AGENDA
ZONING BOARD OF APPEALS
Public Hearing Continuation

ZBA FY2017-00007 – North Square at the Mill District, Beacon Communities LLC, Request a Comprehensive Permit under M.G.L. Chapter 40B, to create a mixed-use, mixed-income development consisting of two new buildings containing 130 residential units, including 20% (26) affordable units, 22,000 square feet of non-residential space, approximately 299 parking spaces, and including site improvements, on approximately 5.3 acre leased site on a 12 acre property at 134 and 92 Montague Road, North Amherst (Map 5A, Parcel 42 and 139; Commercial (Com) and Residential Neighborhood (R-N) Zoning).

PROJECT APPLICATION REPORT

Project Name: North Square at the Mill District

Figure 1 – noise complaints, downloaded from http://maps.amherstma.opendata.arcgis.com/datasets/87ea9519a8ba43518855b860a495613f_0.geojson. The numbers indicate the number of noise complaints at the given location, with dates from 2014 through 2016. No number indicates a single complaint.

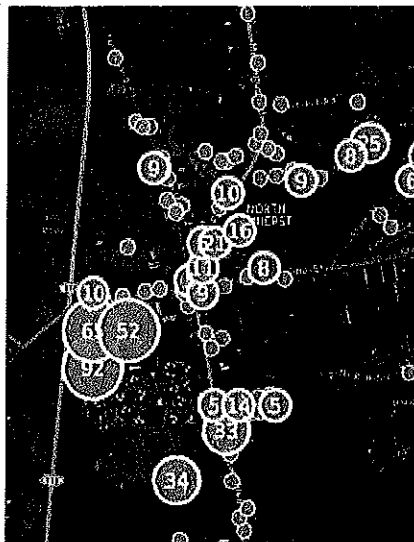
Given likely high student occupancy, noise will be a nuisance to neighbors, based on noise complaints from similar developments as show in the map in figure 1 below.

Figure2 – Commercial / residential boundary missing screening as required by 10.392.

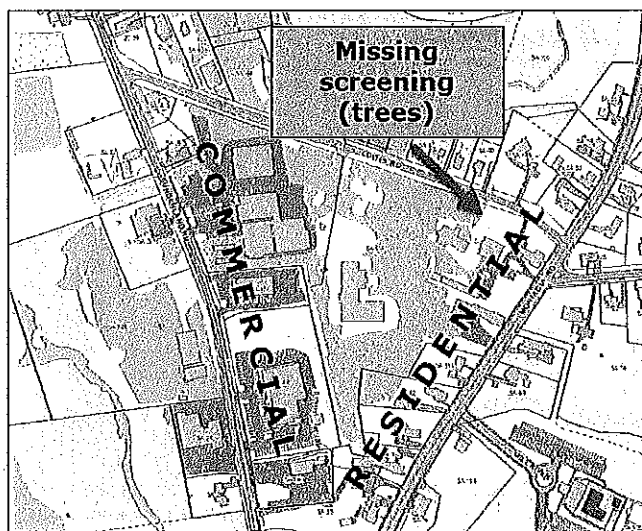
Requiring screening tree plantings between Atkins and the residential portion of 134 Montague as shown in Figure 2 would help address the issues related to 10.392 above. It would also help mitigate noise and lighting related to 10.393 and 10.385. Tall, dense trees along this strip would dramatically reduce the effects of noise, light pollution, and general residential versus commercial landscape characteristics.

Figure 3 – traffic problems at intersection of Cowls and Montague Rd., already impassable by two-way bus and car traffic, may need to be adjusted depending on the outcome of state review. Closing or making the strip one-way west would address the problem, but may require plan adjustments.

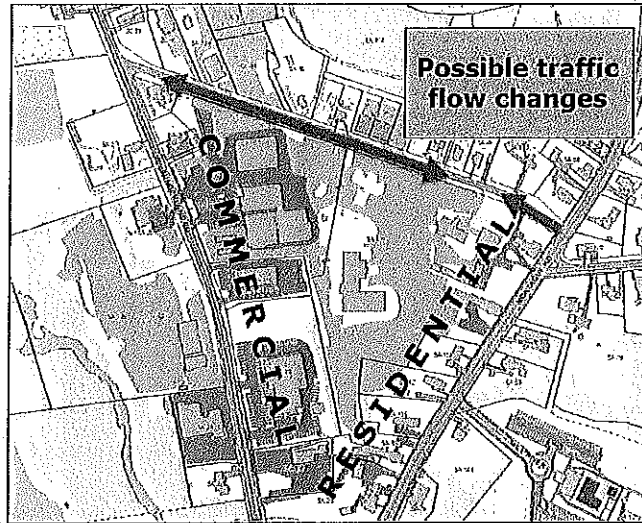
The peer reviewer of the traffic report said that there were likely problems with visibility under increased traffic with the intersection of Cows and Montague Roads, and it is already impassible by busses turning westward when there is eastbound traffic. Beacon did not address this in their plan. Either making that small section of Cows Rd. one-way west, or closing it off entirely, would address the problem, but would require modifications to their plan to accommodate turning traffic, as shown in figure 3 below.
